**RESPONSE TO COUNTY OF
SAN DIEGO REVIEW COMMENTS
FOR ROCKFALL POTENTIAL**

**MEADOWOOD (PANKEY RANCH)
SAN DIEGO COUNTY, CALIFORNIA**

**MARCH 31, 2011
PROJECT NO. 06931-42-01**

GEOCON INCORPORATED GEOLOGICAL CONSULTANTS 6940 FLANDERS DRIVE - SAN DIEGO, CALIFORNIA 92121-2974 PHONE 619 558-6900 - FAX 619 558-6159	SCALE 1" = 60'	DATE 03-31-2011	PROJECT NO. 06931-42-01	FIGURE 1
	SHEET 1 OF 2

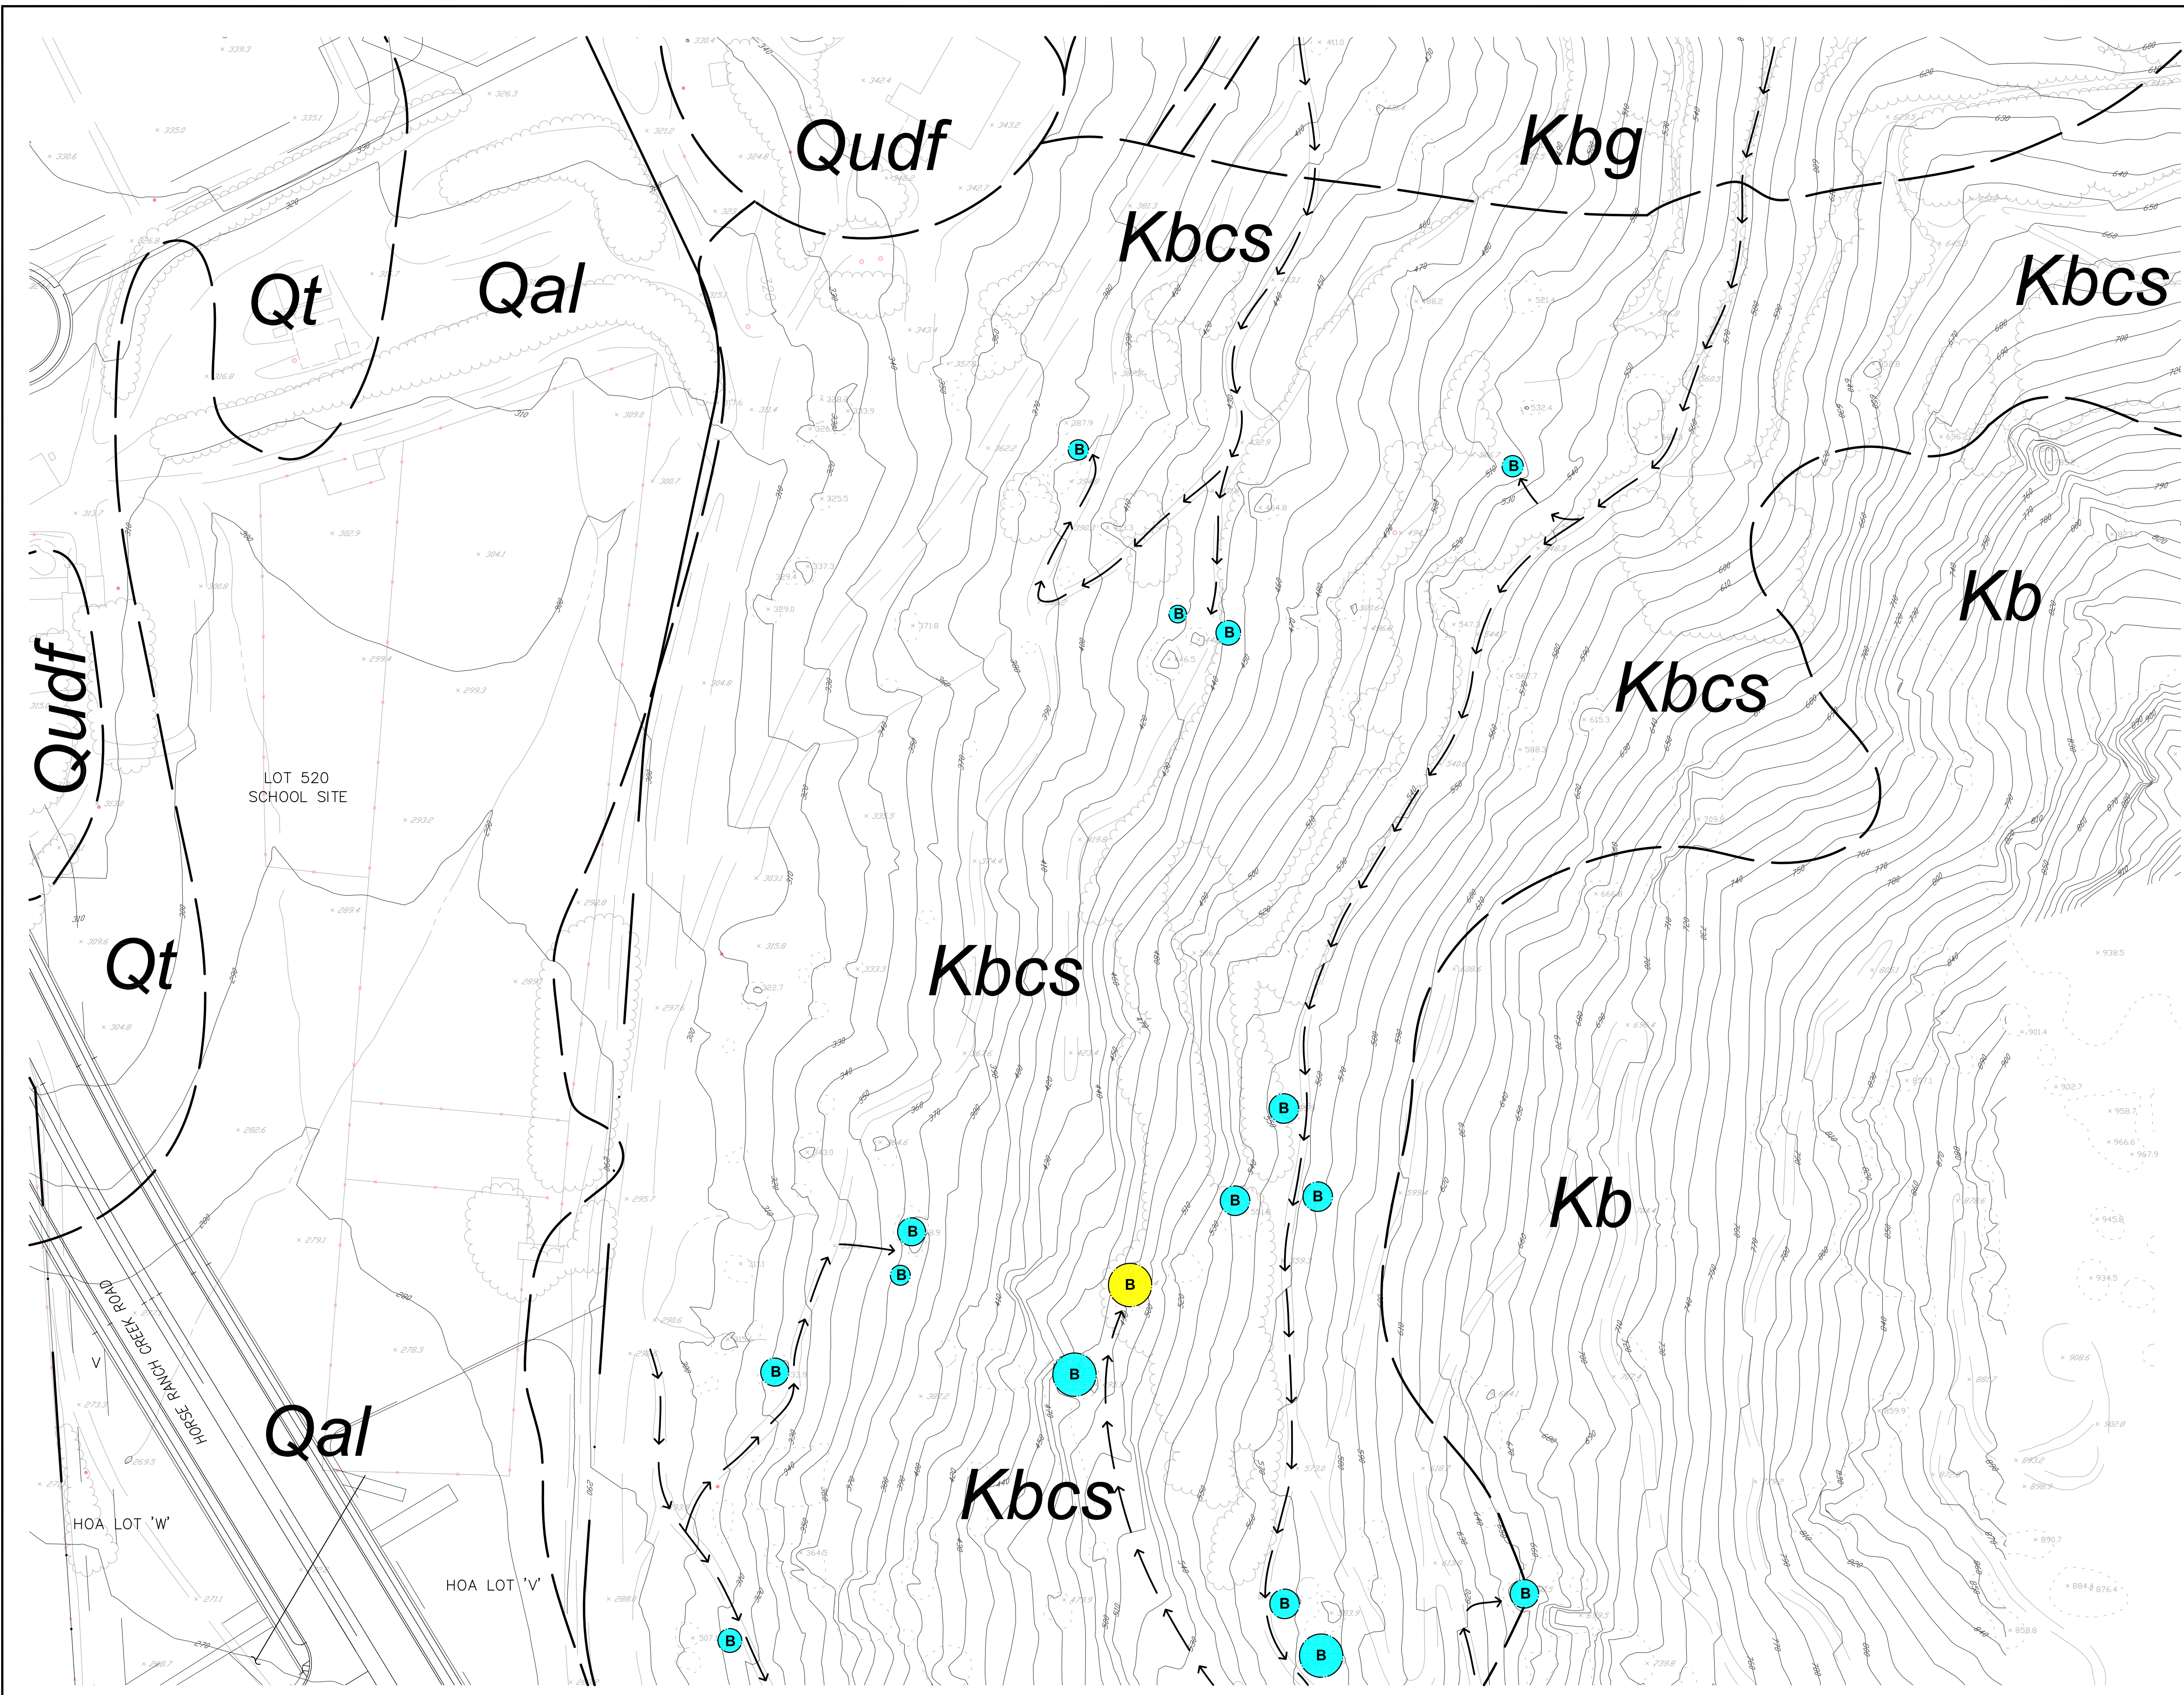
We recommend mitigation of rockfall potential consisting of: (1) identify boulders that have a high potential for rockfall and anchor/rock bolt, break and/or remove these rocks from the hillside; (2) identify boulders that have a less significant rockfall potential, test these rocks with excavation equipment, and remove rocks that move or appear to be unstable; and (3) monitor rocks identified as having a less significant rockfall potential during development of the Meadowood project. Figures 1 and 2 (map pocket) show the approximate locations of specific boulders that have been identified as having rockfall potential. Boulders that appear to have been undercut by erosion or to be precariously balanced are considered as having a high potential for rockfall and should be removed and/or mitigated as recommended hereinafter.

Boulders that do not appear to have been undercut by erosion and are considered to have a less potential for rockfall are also identified on Figures 1 and 2. These boulders should be tested by applying pressure from excavation equipment during rockfall mitigation to see if they are loose or unstable. Loose or unstable rocks should be removed as recommended for rocks that have a high potential for rockfall. Rocks that do not move when tested or have been identified as having a less significant rockfall potential should be monitored during site development as recommended hereinafter.

Four large boulders within or adjacent to Horse Ranch Creek Road are identified on the figures. These boulders should be removed during grading of the roadway.

We have also shown on Figures 1 and 2 the suggested ingress/egress to each of the boulders considered to have a high potential for rockfall, and those that should be tested during rockfall mitigation. For many of the identified boulders, ingress/egress can be achieved by using existing roads and trails. It appears that existing trails/roads can be used to get within approximately 50 feet of the boulders identified as having a high potential for rockfall. An area of disturbance 15 feet in width will likely be required for access to boulders and pushing boulders down the slope. We estimate a width of approximately 15 feet around each boulder will be required to break or anchor the boulders.

1. Boulders identified as having a high potential (eroded at the base or entirely free from the soil) should be broken and removed from the slope, or alternatively rock bolted to the slope. This will require use of an excavator with a rock breaking device or drilling the rock and using chemicals that break rock, or the use of anchors to pin the rock to the slope. Large rocks that are impractical to completely remove or anchor to the slope should be broken down such that they are relatively flat or on contour with the slope face to create a rock with a shape that will not roll.

2. Boulders identified as having a less significant rockfall potential should be tested by applying pressure with the excavator. If the boulders move they should be mitigated as recommended under No. 1. Boulders that are small enough such that they can easily be moved should be pushed or rolled down the slope.

3. Boulders identified as having a less potential for rockfall should be monitored on a weekly basis during grading to assess if movement occurs. Following grading we recommend the identified boulders be observed on a quarterly basis until completion of the Meadowood development. If during the monitoring period boulders move or dislodge, we recommend the boulders be removed as recommended above.

4. During the monitoring period after a period of heavy rain, the boulders should be observed to assess if runoff has caused undermining of the downhill side of the boulder. Removal and/or breaking of the boulders as recommended should be performed if undermining occurs.
